From: Dwight Hoenig [dwight@turnermaclane.com]
Sent: Friday, November 06, 2015 10:38 AM
To: Detterman, Mark, Env. Health; Paul Meuser; Jenilee Houghtailing
Subject: Re: Status and additional sampling data for 1315 Court Street, Alameda

From: Dwight Hoenig [mailto:dwight@turnermaclane.com]
Sent: Friday, November 06, 2015 7:51 AM
To: Detterman, Mark, Env. Health
Cc: Paul Meuser; Jenilee Houghtailing
Subject: Status and additional sampling data for 1315 Court Street, Alameda

Supplemental Soil Data: 1315 Court Street
Samples Collected by Dwight Hoenig, Oct. 25, 2015

FIGURE #3

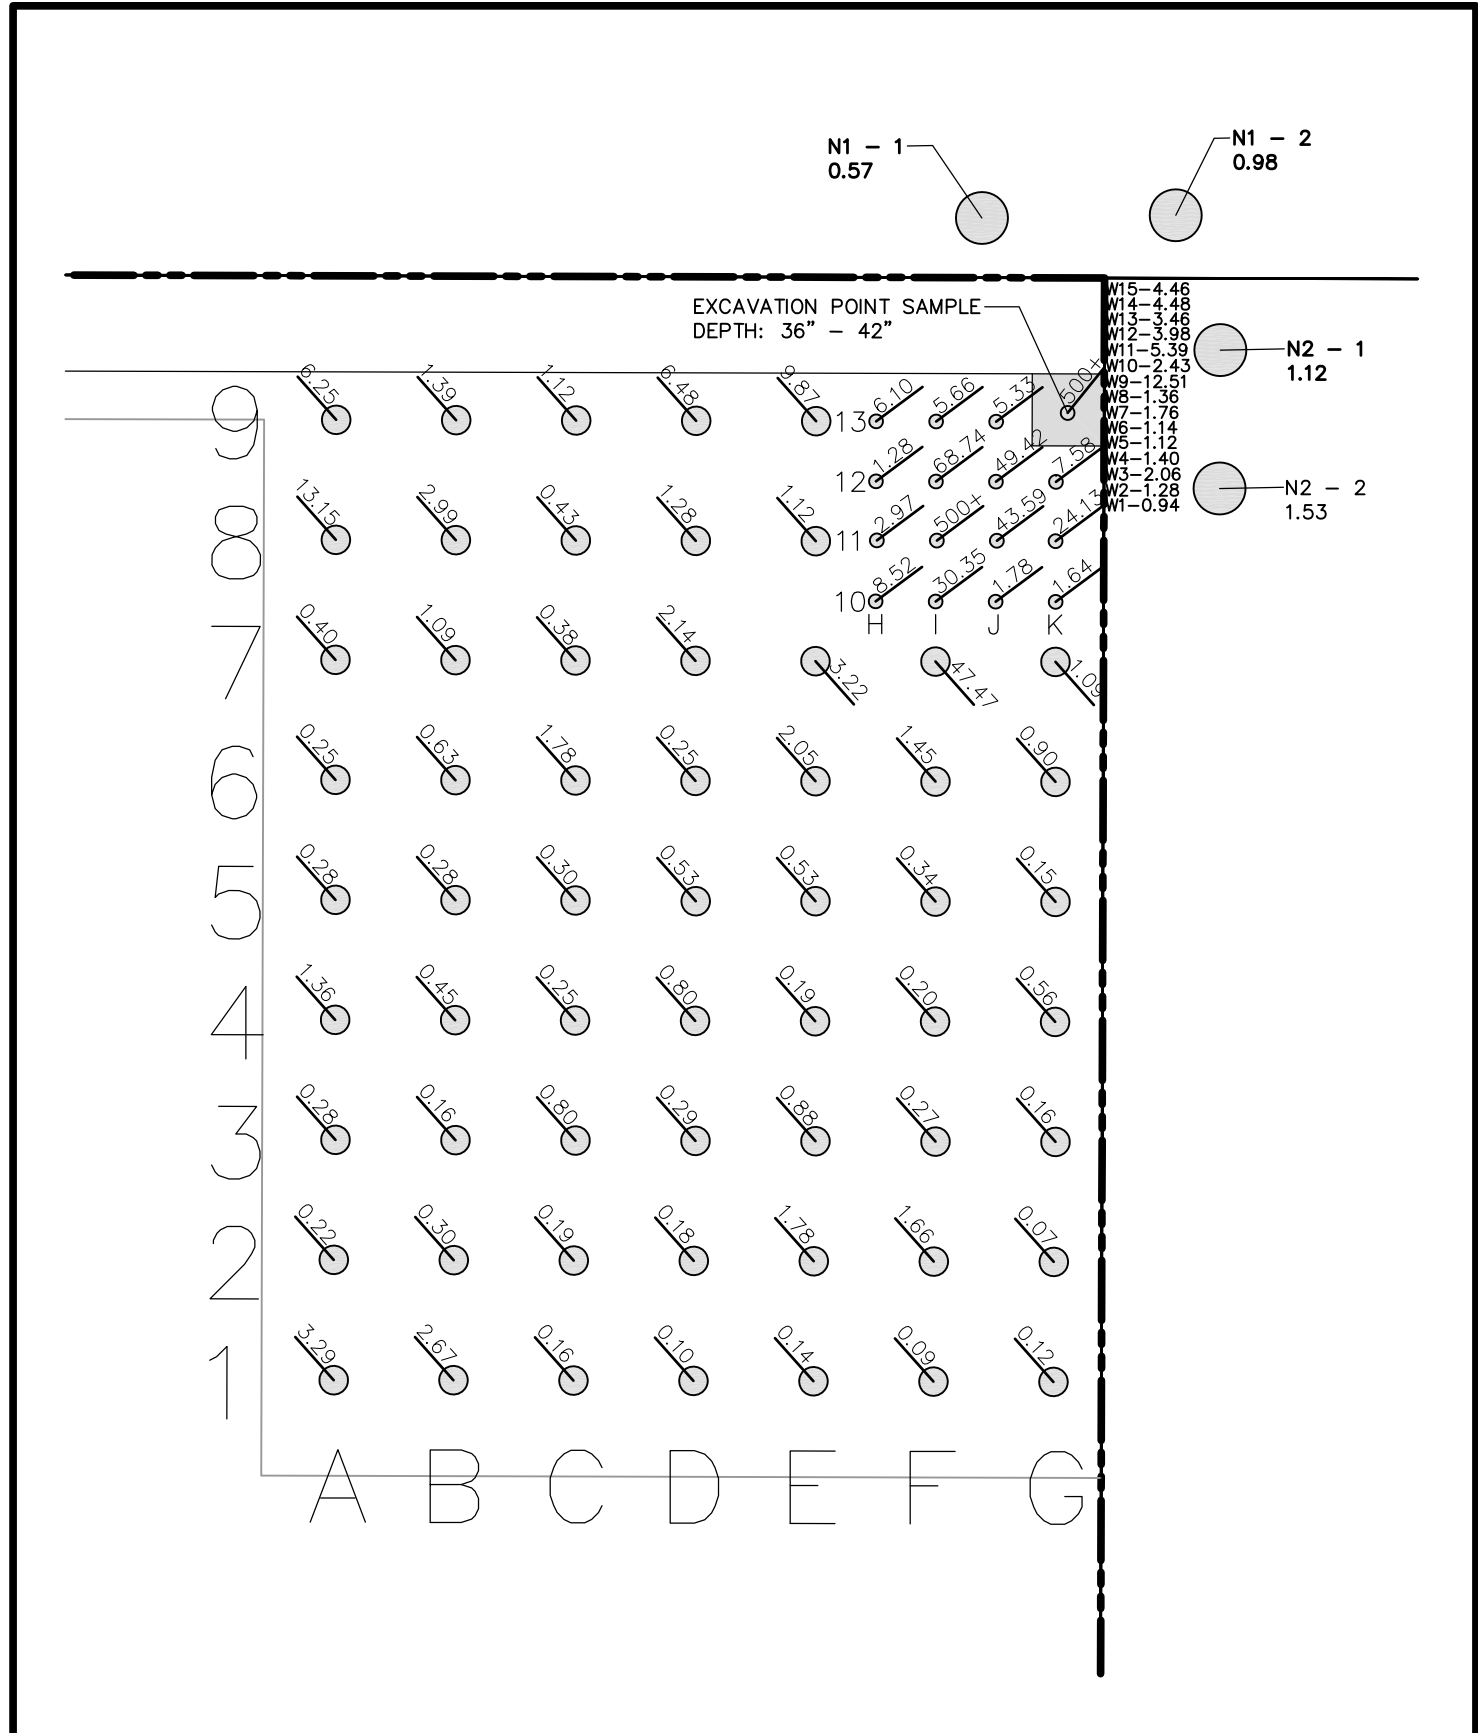
Thanks for the update, and thanks for the extra effort to define the extent of contamination. Your approach appears reasonable in regards to the length of the excavation along the wall; however, due to the imprecision of soil sampling and the ability of soil vapor to travel, I would request that a small box excavation be conducted centered on 8-A (to mid points between adjacent vapor readings) due to a soil vapor concentration (13.15 ug/m³) higher than at 9-E (9.87 ug/m³) which also yielded a soil concentration of 13.0 mg/kg mercury. This extra step appears appropriate due to potentially scattered mercury "disposal" at the address, and to ensure all residual mercury contamination is removed.

That data is provided in the enclosed attachments along with a couple of photos taken during that sampling...and a copy of our previous Figure #3 which will give you a reference for those sampling locations and the associated Vapor Readings from the original sampling.

As you will see...the new sampling data indicates that all values were reported well below the RSL values with the exception of the shallow soil sample at location 9-E. We intend to use this data to modify the original excavation plan to now expand removal to include this 9-E location, while shortening the overall length of the trench excavation to the location of sample point 6-G.

Thanks Mark...with that minor addition....we shall proceed!
Dwight
